SERVICE BULLETIN MAINTENANCE OF WAY EQUIPMENT

DATE: 12-10-2002 / Revised 1-15-2004 **BULLETIN NO:** 02-035

TITLE: 193872 WHEEL SPACER APPLICATION

PRODUCT SERIES / MODEL: All 2001 to present Chevrolet 2500 Vehicles Equipped With HY-RAIL® Guide Wheel Equipment Series 0307, HR0307A, HR0307B or HR1500B Rail Pilot Units.

FIGURE 1 SE02A214A-1
VEHICLE REAR WHEEL

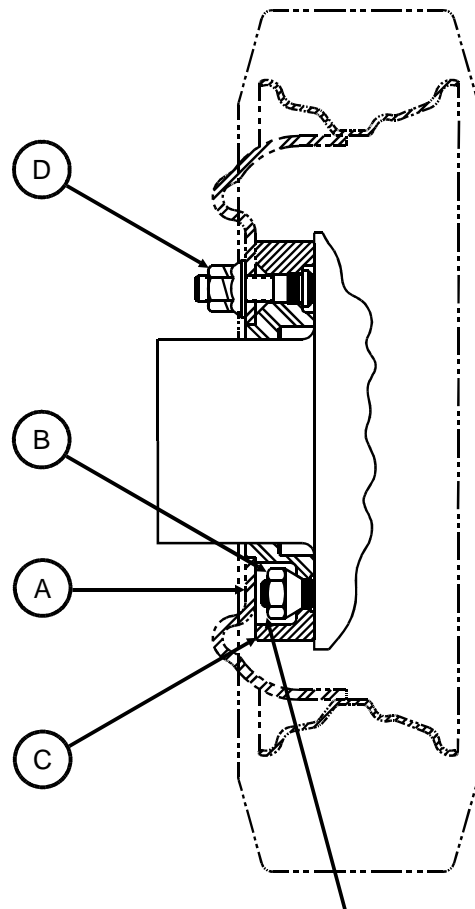
INSPECTING REAR WHEEL SPACER BOLTS - See Figure 1

1. Remove the vehicle rear wheels (A).
2. Verify that all vehicle rear wheel studs and nuts (B) are recessed below the surface of the wheel spacer (C) and do not come in contact with the wheel disc (A).
3. If contact is found between the studs (B) and wheel disc (A), grind the end of the studs until they are recessed below the surface of the wheel spacer (C).
4. If contact is found between the wheel nut (B) and wheel disc (A), either:
 - 4.1 Grind the surface of the nut (B) until it is recessed below the surface of the wheel spacer (C).
 - 4.2 Call HTT for a replacement spacer part # 193872.
5. Re-torque all rear wheel spacer nuts (B) to 140 Ft-Lbs.
6. Remount the vehicle rear wheels (A) and torque the wheel nuts (D) to 180 - 200 Ft-Lbs if Zinc coated or to 140 Ft-Lbs if Magni coated.

STUDS AND NUTS (B) MUST BE RECESSED BELOW SURFACE OF WHEEL SPACER (C) AND MUST NOT CONTACT WHEEL DISC (A)
